OHIO TURNPIKE COMMISSION

ADDENDUM NO. 1

CONTRACT NO. 43-12-03
**BRIDGE REHABILITATIONS
OVER OHIO TURNPIKE
WILLIAMS COUNTY, OHIO**

CONTRACT 43-12-03 SHEET 25 OF 69

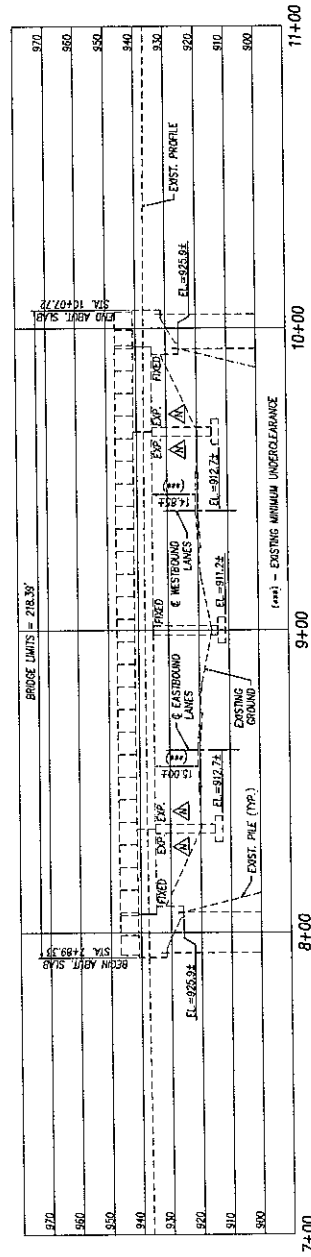
Plan Sheet 25 of 69: Revised quantity for Item SP 519 – PATCHING CONCRETE STRUCTURES from 200 to **235** SQ FT. Removed Item 848 – ~~FULL DEPTH REPAIR~~, which is now incorporated in Item 519 (PATCHING)

CONTRACT 43-12-03 SHEET 28 OF 69

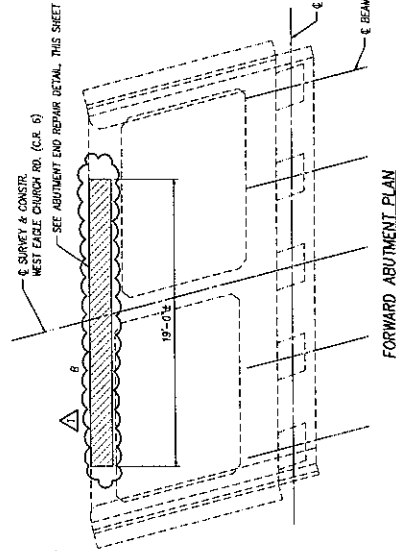
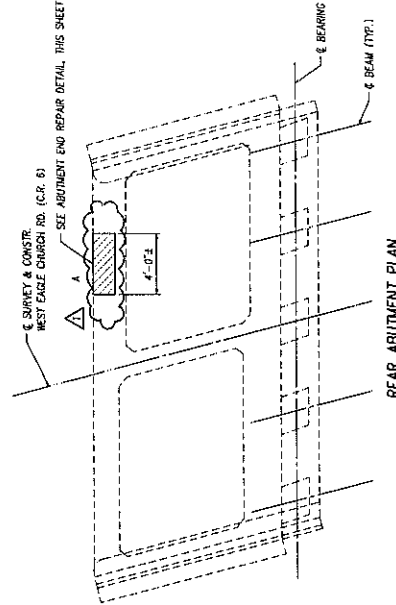
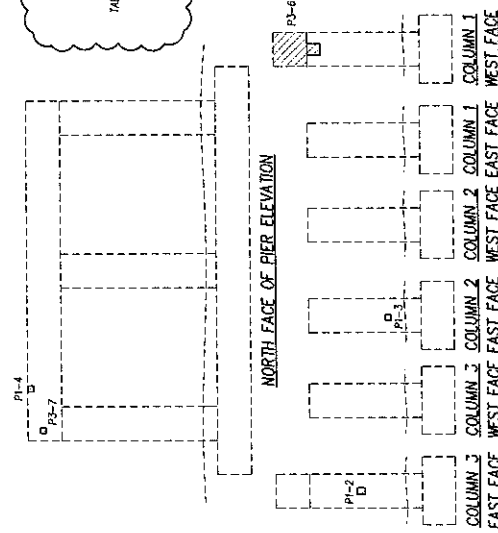
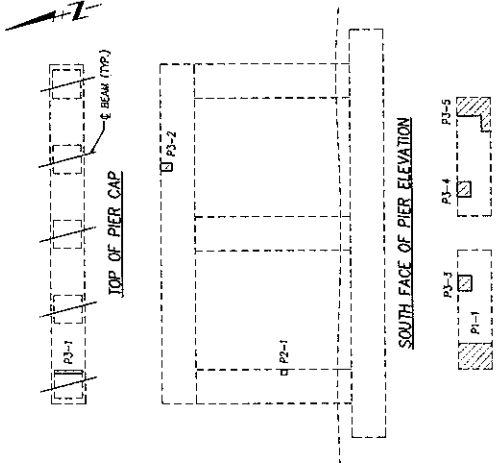
Plan Sheet 26 of 69: Removed ~~FULL DEPTH REPAIR QUANTITIES TABLE~~ and revised PATCHING CONCRETE STRUCTURE TABLE for pricing as Item SP 519 – PATCHING CONCRETE STRUCTURES in lieu of Item 848 – ~~FULL DEPTH REPAIR~~.

TABLE REMOVED, SINCE ITEM MOVED TO SIS PATCHING TABLE ABOVE

CONTRACT 43-12-03 SHEET 40 OF 69

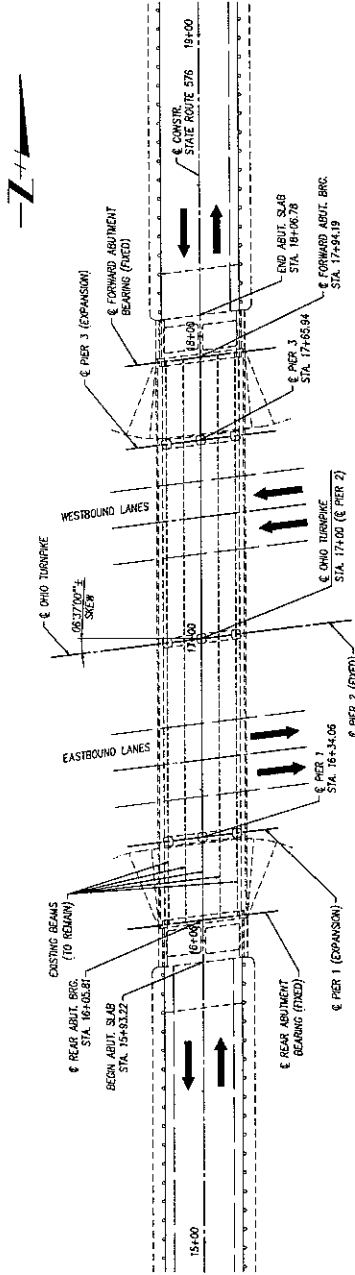
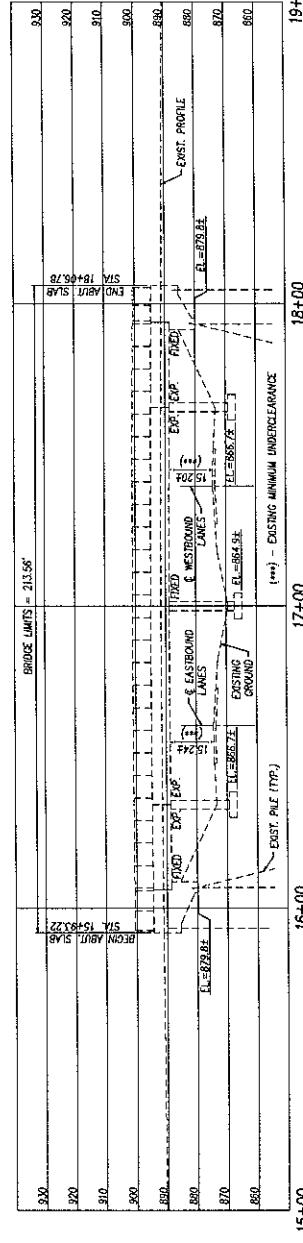
Plan Sheet 40 of 69: Added ***Item 511 – CLASS S CONCRETE with a quantity of 3 CU YD.***

MP 10.20 ABUTMENT SLAB REPAIR DETAILS

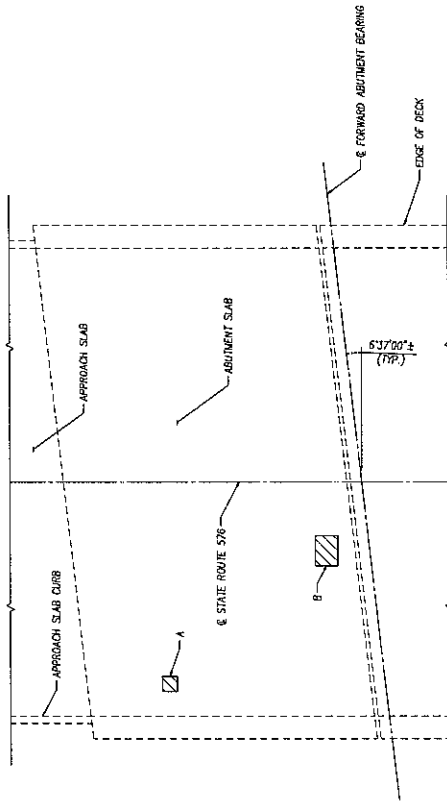
Plan Sheet 42 of 69: Added **table** identifying concrete used in SP 533H Work as **Class S Concrete**.

FULL DEPTH CLASS 5 CONCRETE (SP 533M)				
LOCATION	APPROX. SIZE (FEET)	QUANTITY	AREA (SQ. FT.)	VOLUME (CU. YD.)
R.A. COMPRESSION SEAL (SUBSTRUCTURE SIZE)	1.00x3.4'	1	3.4	3.4
R.A. COMPRESSION SEAL (SUPERSTRUCTURE SIZE)	0.83x3.4'	1	2.82	2.82
TOTAL			6.49	6.22
TOTAL VOLUME				3

GENERAL PLAN AND PROFILE
MP 13.20 (RAMP) - STATE ROUTE 15
OVER OHIO TURNPIKE RAMP

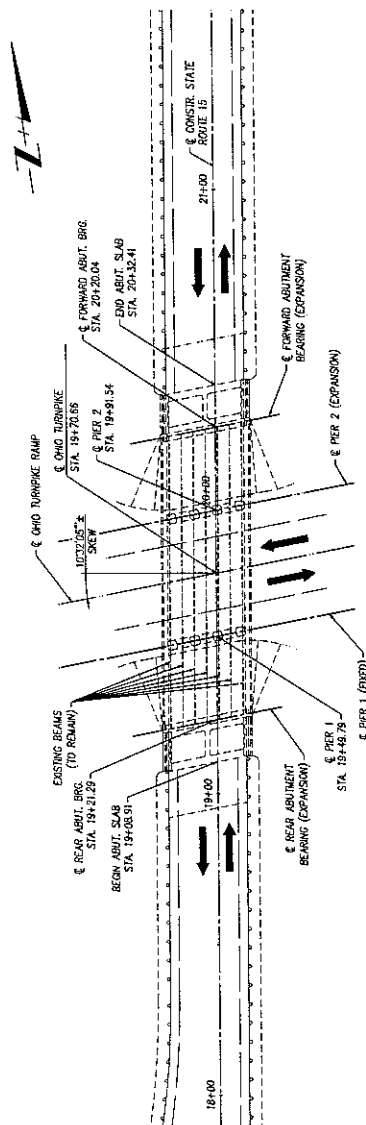
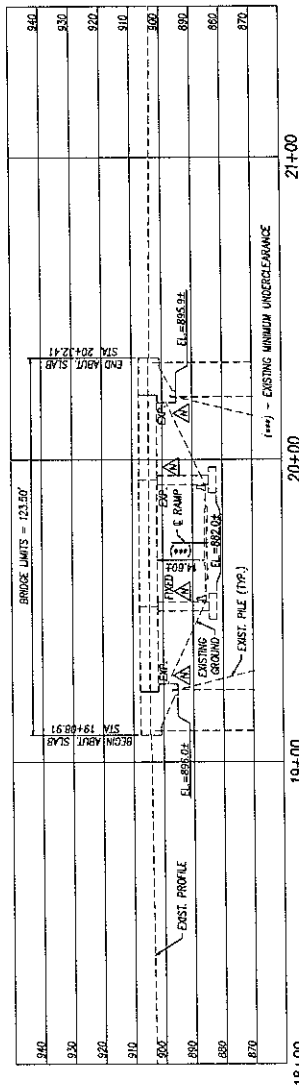
Plan Sheet 53 of 69: Added **Item 511 – CLASS S CONCRETE with a quantity of 7 CU YD**. Revised quantity for Item SP 519 – PATCHING CONCRETE STRUCTURES from 50 to **55 SQ FT**. Removed ~~Item 848 – FULL DEPTH REPAIR~~, which is now incorporated in Item 511 and Item 519

STATE ROUTE 15 OVER OHIO TURNPIKE RAMP - BRIDGE SLAB PLAN
APPROXIMATE AREAS OF FULL DEPTH OVERLAY

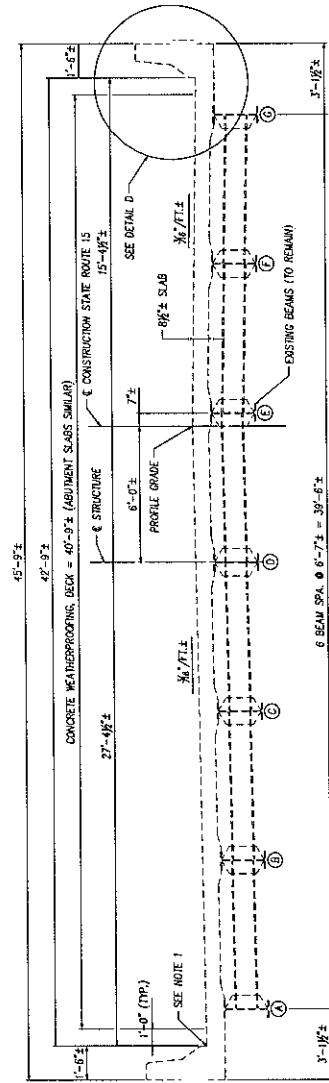
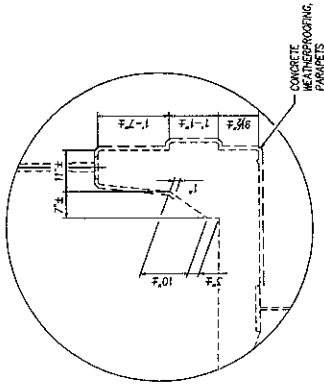
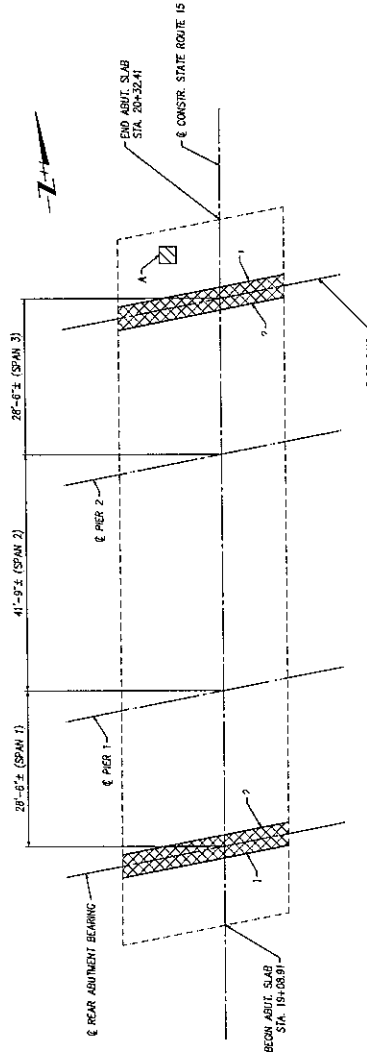
Plan Sheet 55 of 69: Deleted table titled ~~VARIABLE DEPTH OVERLAY QUANTITIES~~ and added table identifying **PATCHING ABUTMENT SLAB CONCRETE**. Retitled FULL DEPTH OVERLAY QUANTITIES table as **FULL DEPTH CLASS S CONCRETE (SP533H)** specifying concrete used in SP 533H Work as **Class S Concrete**. Revised Note 3 to perform repairs of the Abatement Slab Units as specified by Item SP 519 – PATCHING CONCRETE STRUCTURES and sealed as specified by SP 536 – CONCRETE WEATHER PROOFING, and deleted reference to ~~Item 848 – FULL DEPTH REPAIR~~.

PATCHING ABUTMENT SLAB CONCRETE	
CONCRETE PATCH ID	AREA (SQ. FT.)
A	4.0
SUB-TOTAL	4.0
TOTALS CARRIED TO SHEET 63/69

FULL DEPTH CLASS S. CONCRETE (SP 533H)			
LOCATION	APPROX. SIZE (FEET)	QUANTITY (CY)	VOLUME (CU. YD.)
1	1.08x1.7	2	101.5
2	0.83x1.7	3	78.0
			71.5
TOTAL			179.5
TOTAL VOLUME			181.5

OHIO TURNPIKE COMMISSION
EXISTING PARAPET REPAIR
DETAILS AND PATCHING TABLE

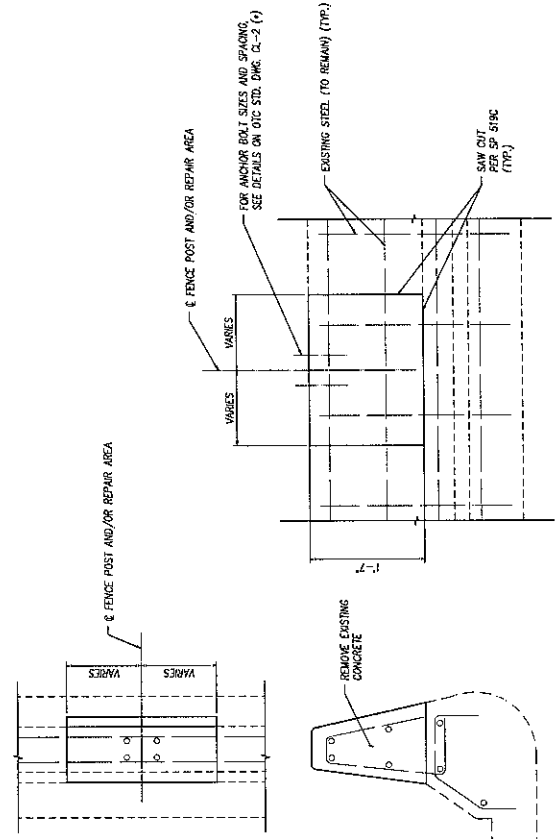
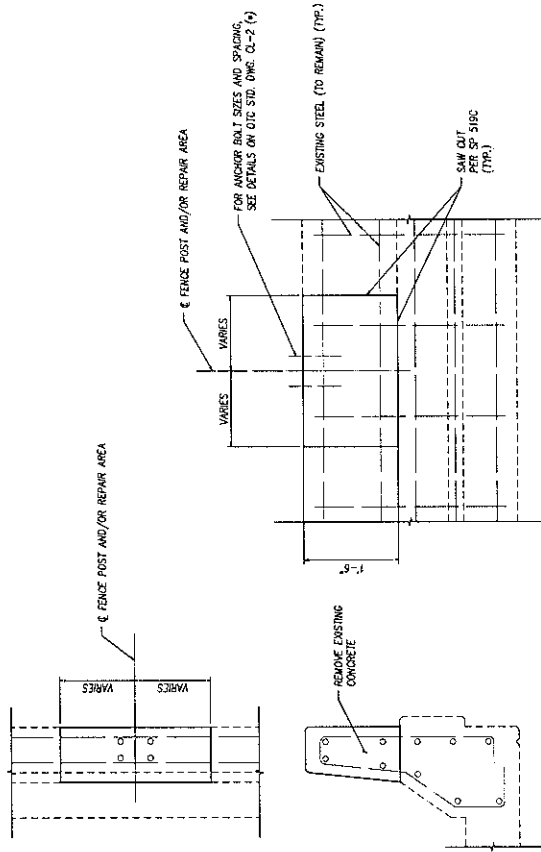
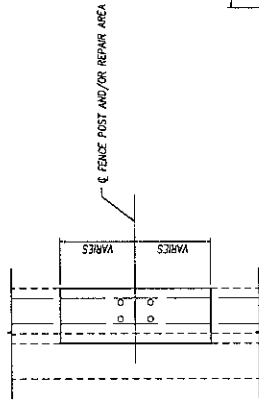
Plan Sheet 63 of 69: Revised SP 519 PATCHING CONCRETE (SUBSTRUCTURE) quantity for MP 5.10 from 35 SQ FT to **70 SQ FT**, and subtotal and total from 200 to **235**. Revised SP 519 PATCHING CONCRETE SUPERSTRUCTURE for MP 13.20 (Ramp) from referencing Sheet No. NA to Sheet No. **55**, the quantity from NA SQ FT to **5 SQ FT**, and the subtotal and total from 50 SQ FT. to **55 SQ FT**.

JOINT DETAILS

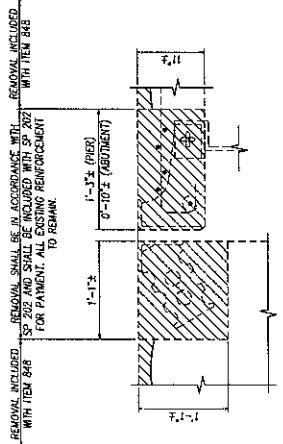
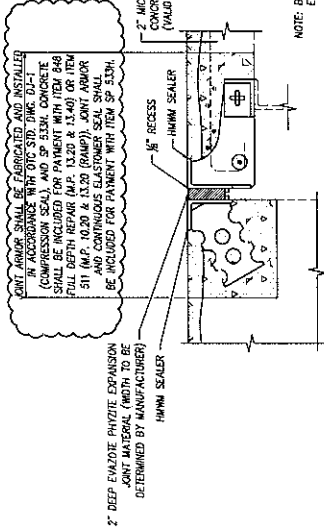
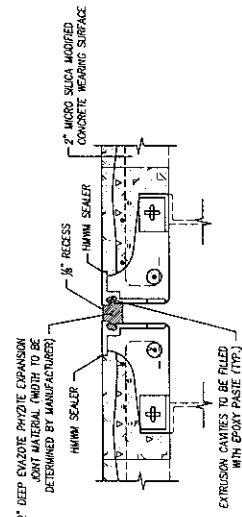
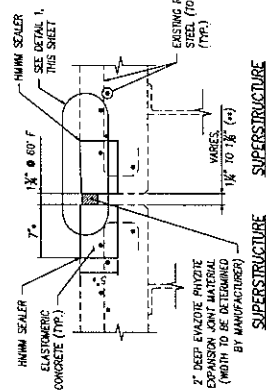
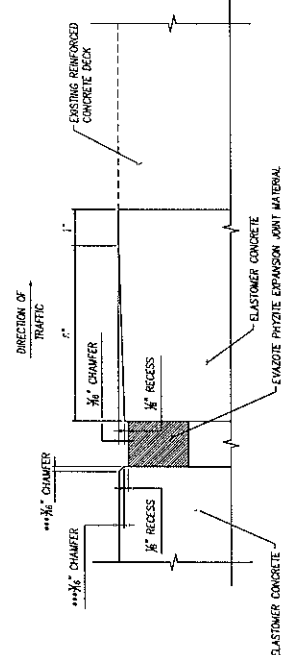
Q#1 Structure MP 10.20 has quantity for Item SP 533H at the rear abutment. Per Plan Sheet 65 new concrete for this joint replacement shall be included with Item 848 Full Depth Repair. No quantity has been included in Item 848 Full Depth Repair for Structure MP 10.20. Only quantities for MP 13.20, 13.20 Ramp, & 13.40 have been included in Item 848 Full Depth Repair. Please verify.

Plan Sheet 65 of 69: Revised Note in SP 533H Detail to add that payment for **concrete at MP 10.20 and 13.20 (RAMP) is to be included in Item 511**.

A#1 *The reference on Plan Sheet 65 to new concrete to be included with Item No. 848 is accurate only for those bridges which have Item No. 848 – MICRO SILICA MODIFIED CONCRETE OVERLAY USING HYDRODEMOLITION, 2" THICK (MP 13.20 and MP 13.40). For those locations where there is no intended hydrodemolition, the new concrete is to be paid for as Item 511 – CLASS S CONCRETE, which has been added to the Plans as part of this Addendum No. 1. The Plan Sheets and quantities have been revised to reflect this. In addition, there were two (2) other locations where the patching of the deck concrete was inadvertently included as Item No. 848 – FULL DEPTH REPAIR. These locations on MP 5.10 and MP 13.20 (Ramp) have been revised to price this Work as Item No. 519 – PATCHING CONCRETE STRUCTURES. The following Plan Sheets have been revised to reflect the revisions to the quantities and the Bid Items: 2, 25, 26, 40, 42, 53, 55, 63 and 65 (see changes outlined below in this Addendum No. 1 and the attached replacement Bid Form and Plan Sheets).*
